30. COUNTY DEPARTMENT OF HEALTH AND ENVIRONMENT
INDIVIDUAL SEWAGE DISPOSAL SYSTEM INSPECTION FORM

Address 7345 ADVENTURE WAY 80908 Owner Mountain Springs Church

INDIVIDUAL SEWAGE DISPOSAL SYSTEM PERMIT

APPLICATION FOR AN ON-SITE WASTEWATER TREATMENT SYSTEM PERMIT

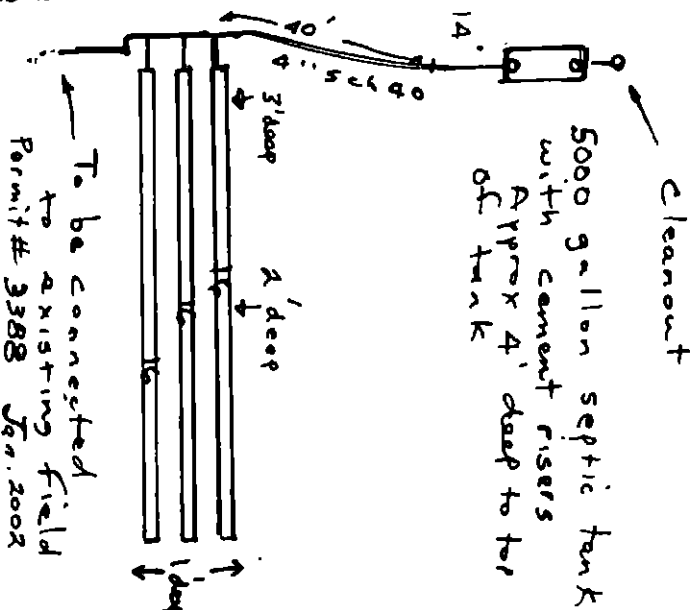
NOTES: Sewer line for church was installed by Hoier (Dan) Excavating ph. 499-6491. Not inspected by Health Dept. Cleanouts (pipe above ground) are > 50' lengths. Entire Sewer line was covered.

Septic tank & 14' of sewer line inspected 28 Jul 06
40' of sewer line and Absorption field inspected 10 Aug. 06

2250 gallon Existing Septic Tank (To be Abandoned) Permit # 3388 Jan. 2002
